CITY OF SANTA BARBARA

COUNCIL AGENDA REPORT

SUBJECT: Appeal Of Historic Landmarks Commission Approval Of 1330 Chapala Street

Subject: Appeal of the August 14, 2013 Historic Landmarks Commission approval of the Preliminary Design Review and Development Plan Findings For 1330 Chapala Street Mixed Use Project (Arlington Village)

② Site/Parking Plan
1/16 = 1'-0"

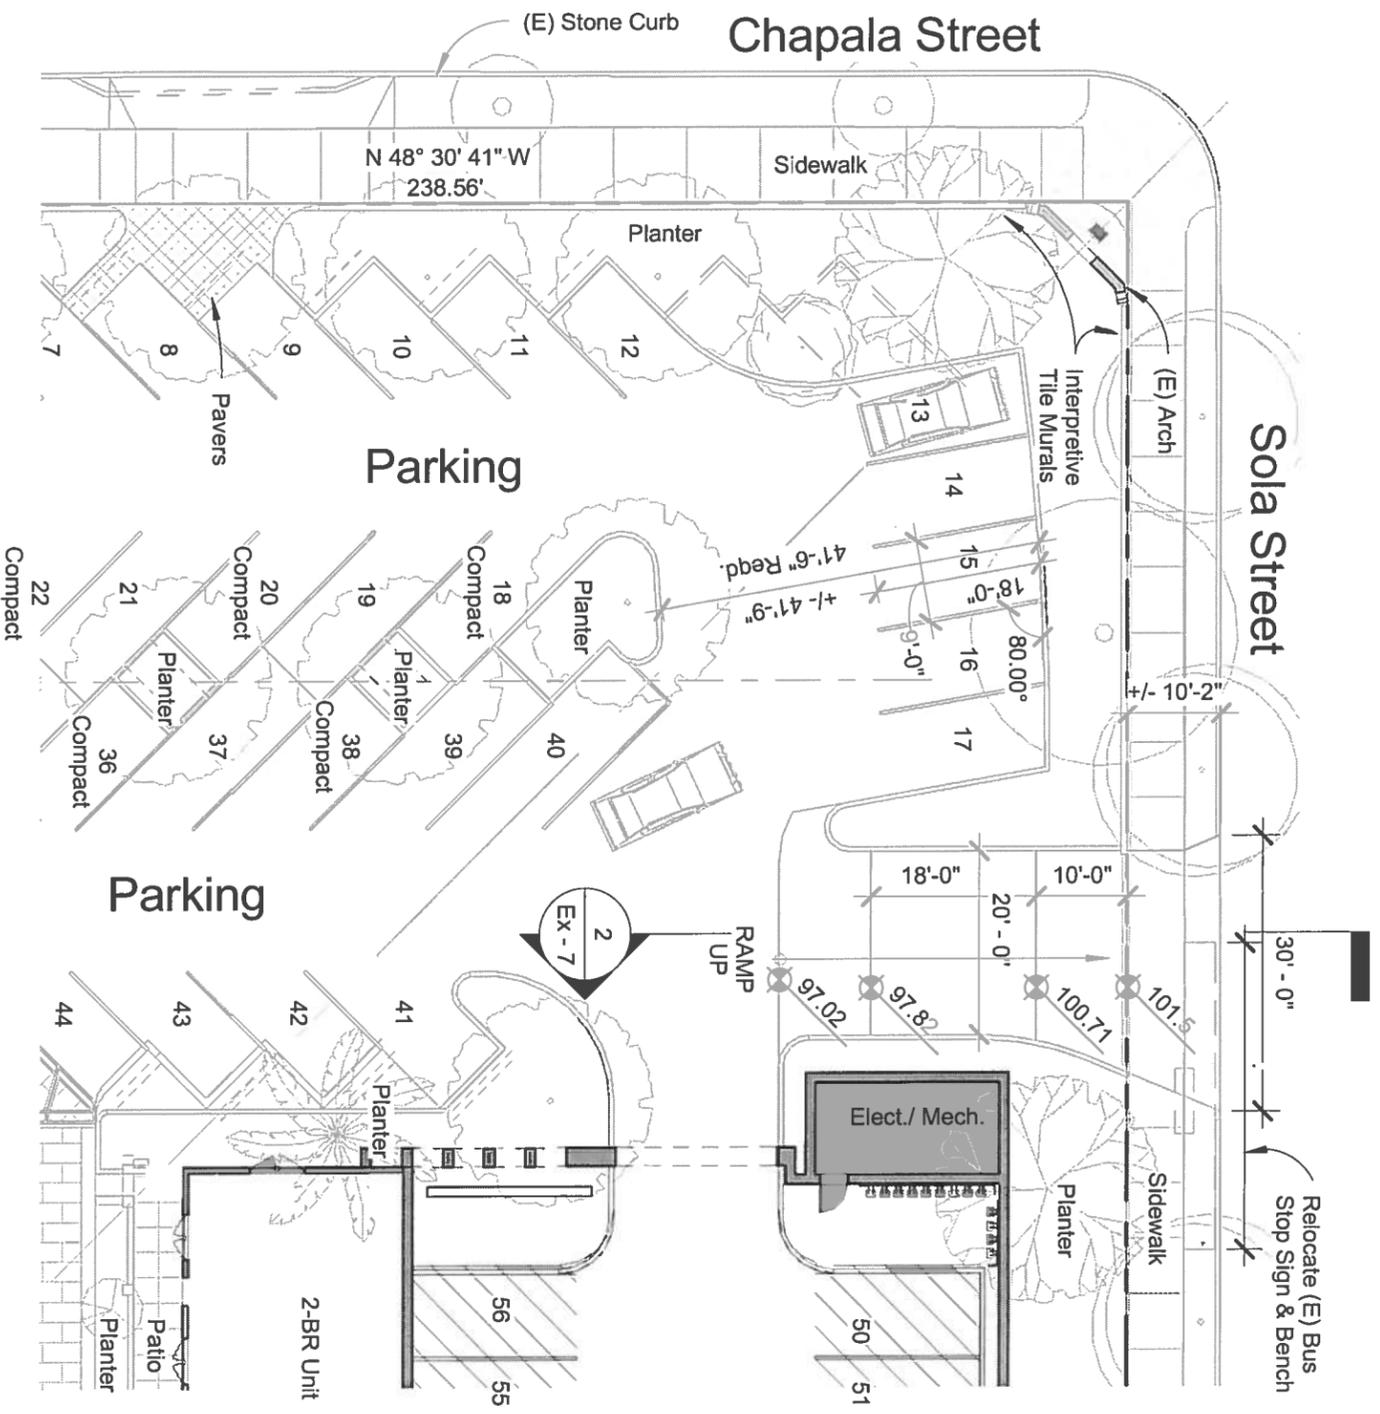
Since the approval of the project at the Historic Landmarks Commission (HLC) on August 14, 2013 our team has modified the site plan by adding a secondary point of ingress and egress. It had been our desire to provide a secondary driveway from Sola Street as we felt that it would improve circulation on the site. But, upon initial assessment by our civil engineer, Penfield & Smith (P&S), it appeared that the grades were too steep for the driveway to meet the City's slope requirements. Please note that there has been no change to the building design that was approved by HLC.

Once the project was appealed by Marge Cafarelli, we sat down with P&S and our transportation consultant, Associated Transportation Engineers (ATE), to review the matter again. Our team discovered that, with the reconfiguration of the drainage plan and the parking layout, we could provide the secondary point of ingress and egress. We were pleased that this new driveway could be included. The provision of the driveway resolved Ms. Cafarelli's key concern about traffic loading at the Chapala Street driveway and site circulation.

In addition, the provision of the Sola Street driveway allowed us to remove the existing secondary point of egress off of Chapala Street. This driveway was planned to be used as a point of exit by the trucks/buses supporting the 10-12 live performances that require them. They are now planned to exit the site at the Sola Street driveway. Transportation staff reviewed the revised site plan and were supportive of the changes.

FIGURE 2

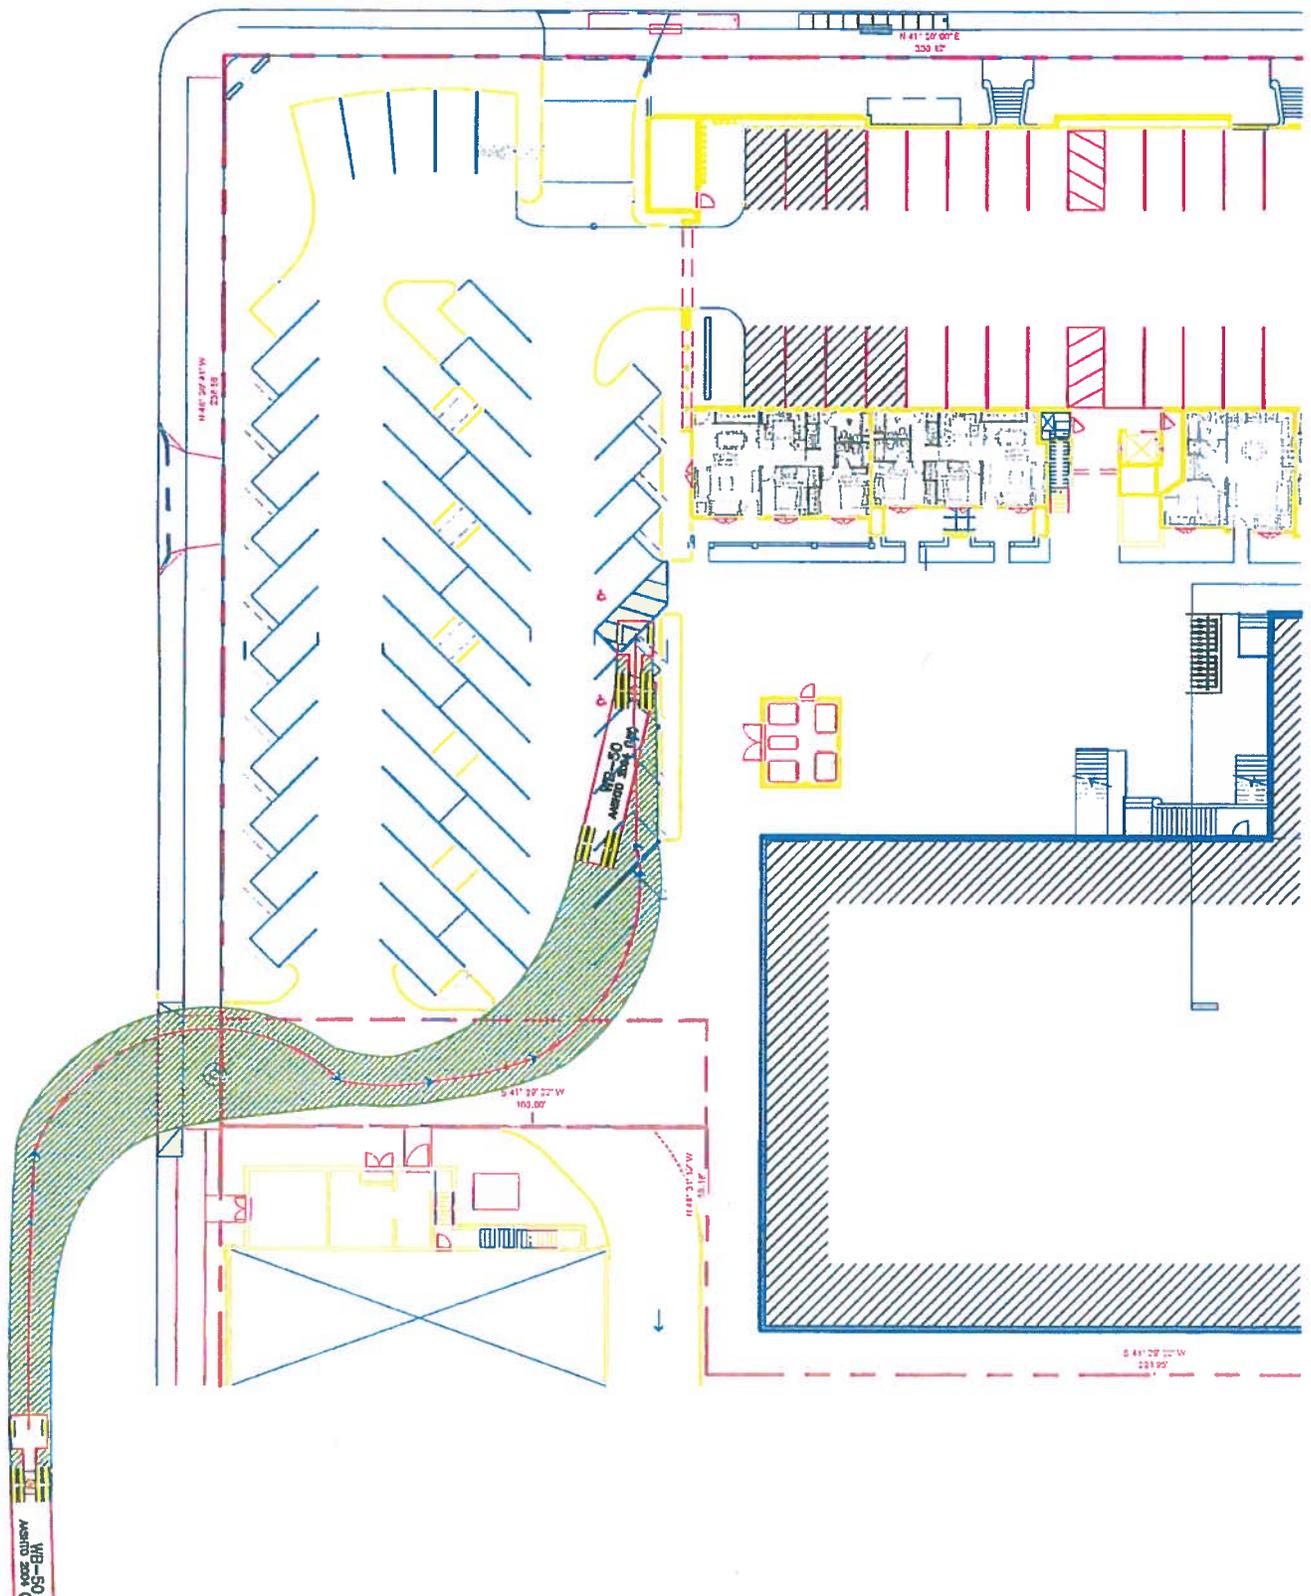
- Reserve 5 parking spaces within the Arlington Theater parking lot to facilitate truck movements and loading. The parking spaces will be blocked off on the days when trucks are needed for events and the spaces will be restricted with no overnight parking allowed. The theater is closed during the loading and unloading periods thus there would be no demand for event parking. Figure 2 shows the location of the parking spaces that will need to be temporarily restricted during the loading/unloading periods.

- e. Thirteen parking spaces within the Arlington parking lot shall be reserved and blocked to facilitate truck movements, parking and loading per figure 2 of the Truck Access and Management Plan.

FIGURE 4

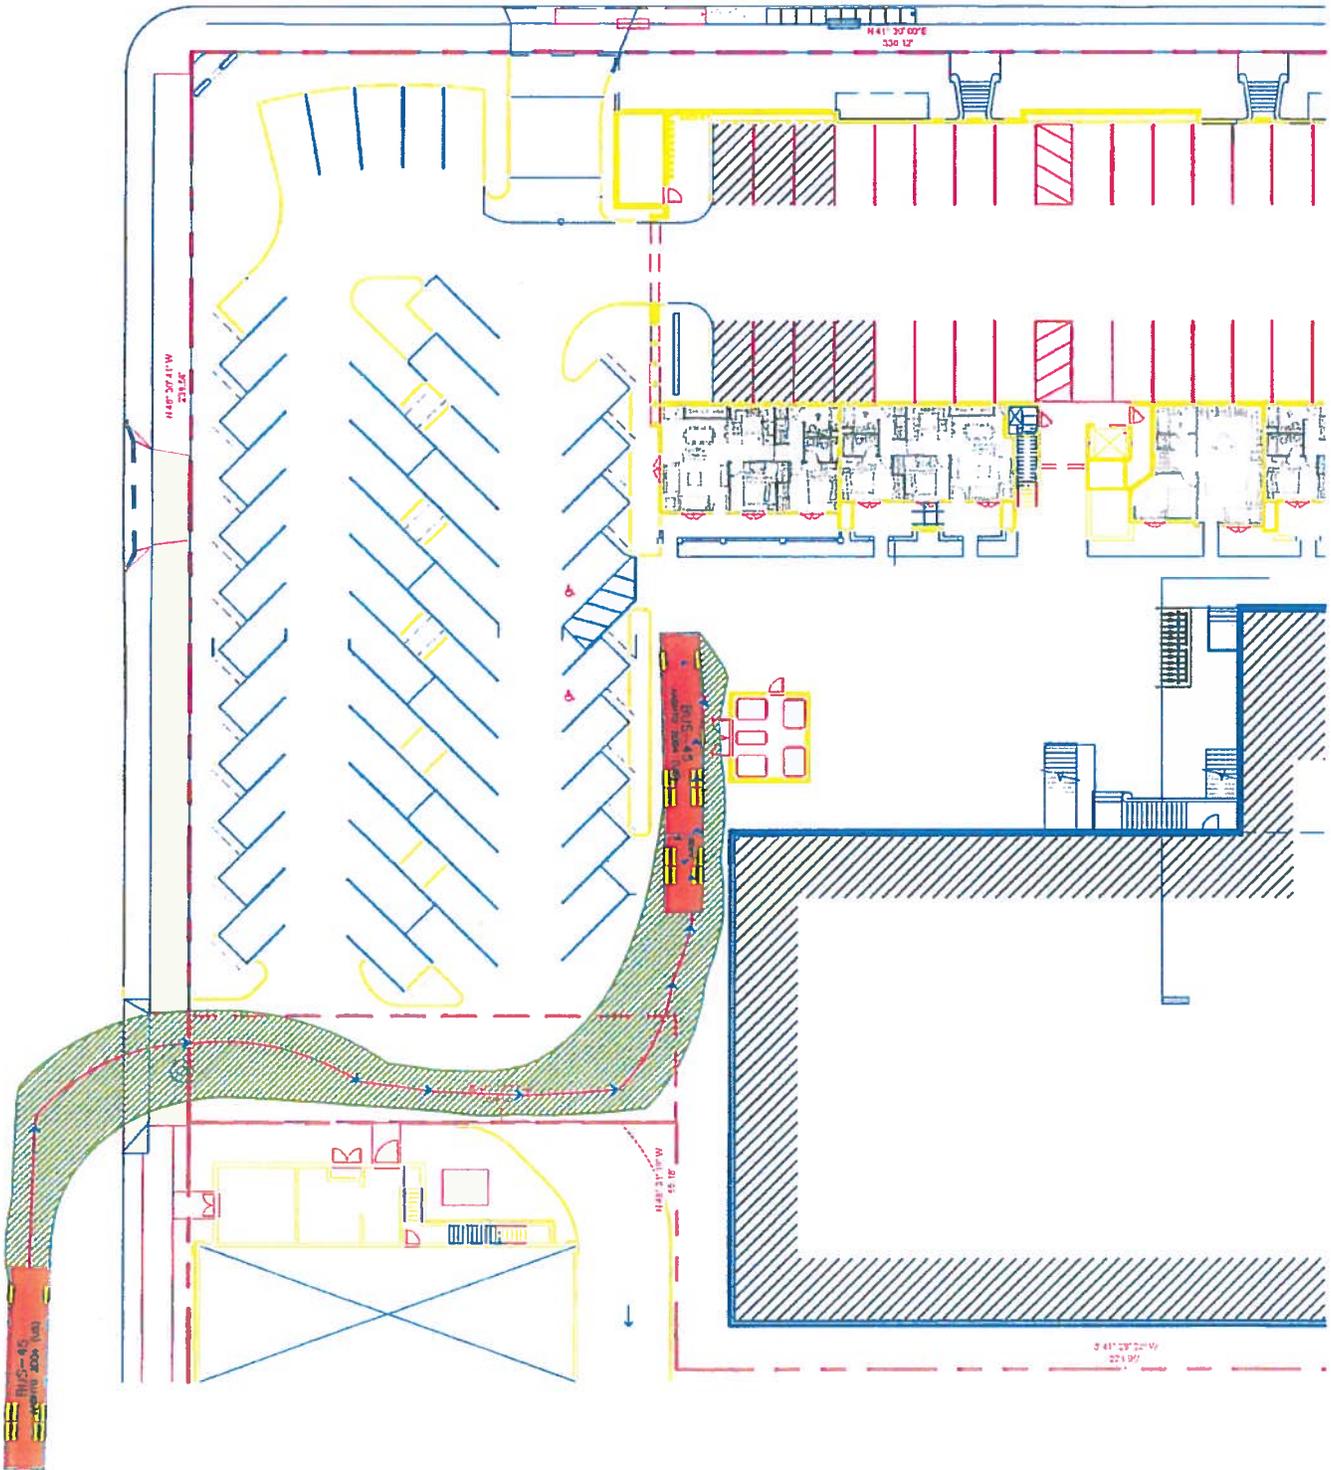
Inbound. Trucks and buses would enter the site via the existing southern driveway on Chapala Street. Trucks would proceed east along drive aisle and park in the first parking bay located west of the Arlington Theater. Buses would temporarily park in the paseo area adjacent to the trash enclosure (see Figure 3). Figures 4 and 5 show the inbound truck and inbound bus movements into loading areas.

FIGURE 6

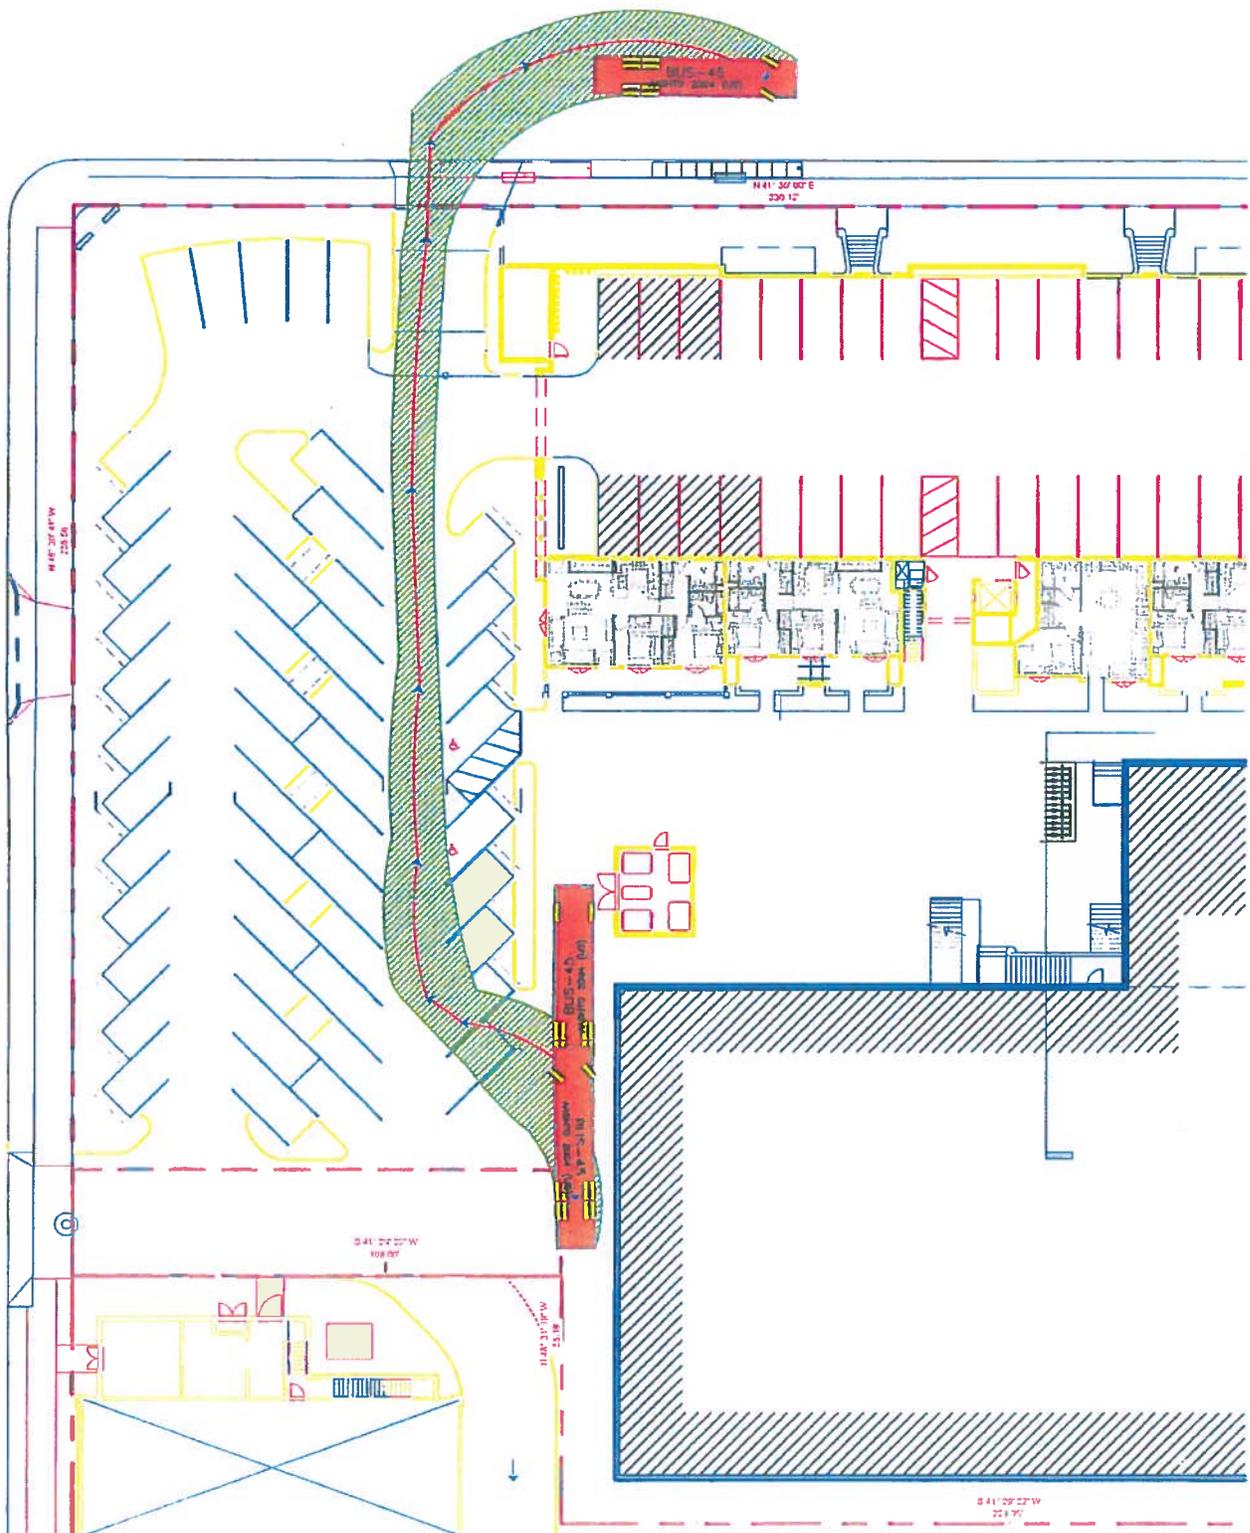
Outbound. Trucks and buses leaving the site would utilize the proposed driveway on Sola Street to exit the site. Figure 6 and 7 show the outbound truck and bus movements from the loading/unloading areas. It is noted that on-street parking would need to be restricted along the north side of Sola street opposite the driveway in order to accommodate the outbound truck movement.

FIGURE 8

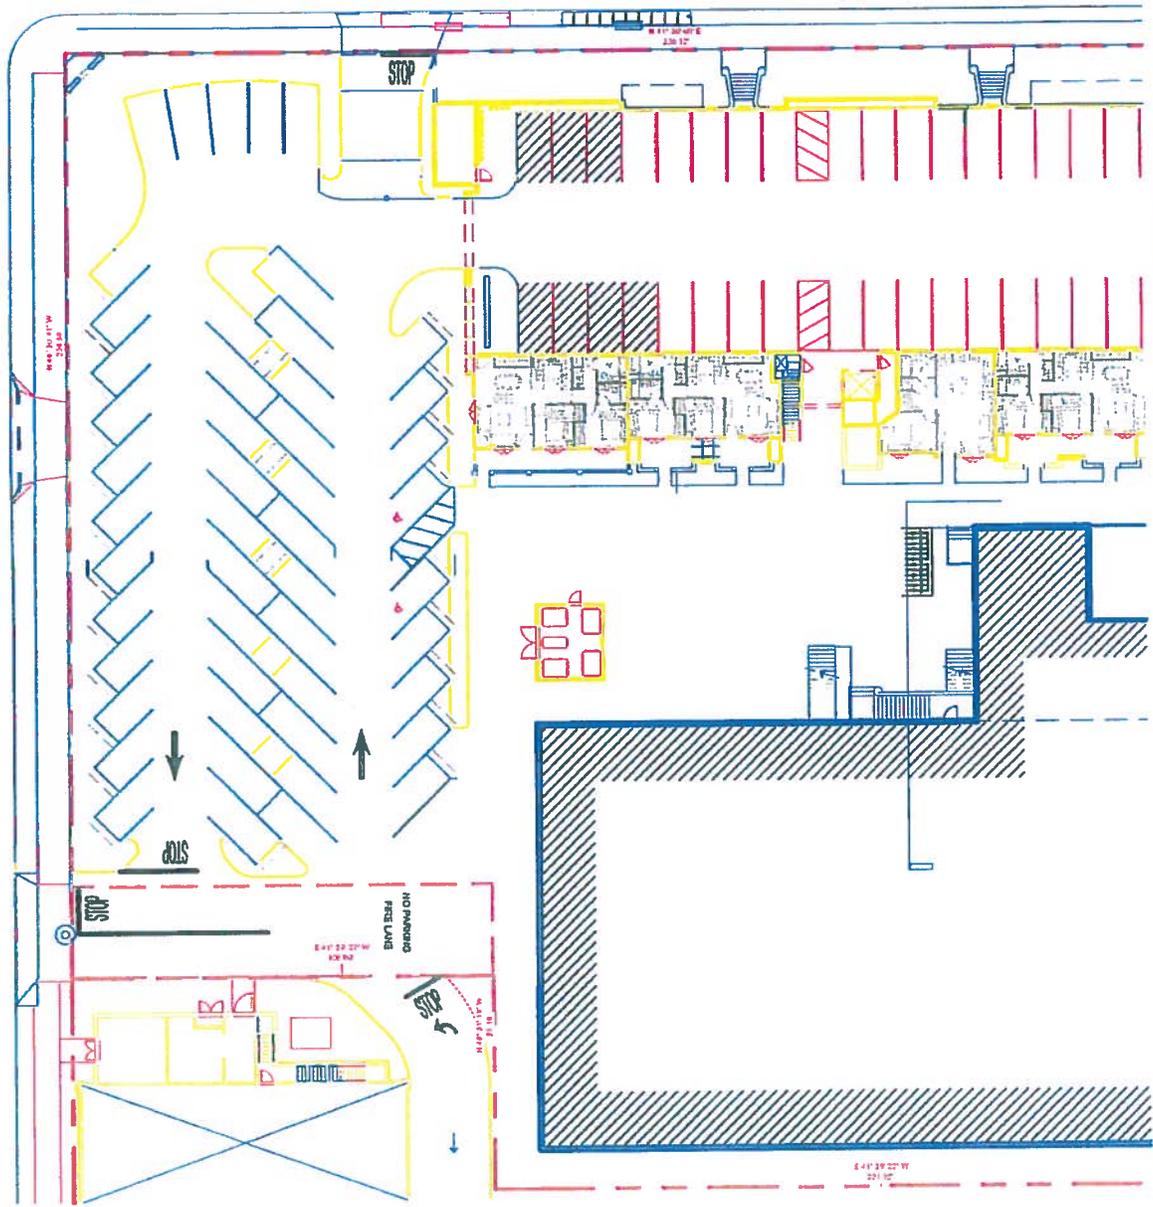
Inbound. Garbage trucks would enter the site via the existing southern driveway on Chapala Street (see Figure 8). Garbage trucks would proceed east along the 24-foot drive aisle and pull into the paseo area located at the northwest corner of the Arlington Theater. The garbage bins would be rolled from the storage shed located in this area to the trucks.

Outbound. Garbage trucks would back out of the paseo area towards the south end of the Arlington Theater. The trucks would then turn left and exit the site via the driveway on Chapala Street (see Figure 8).
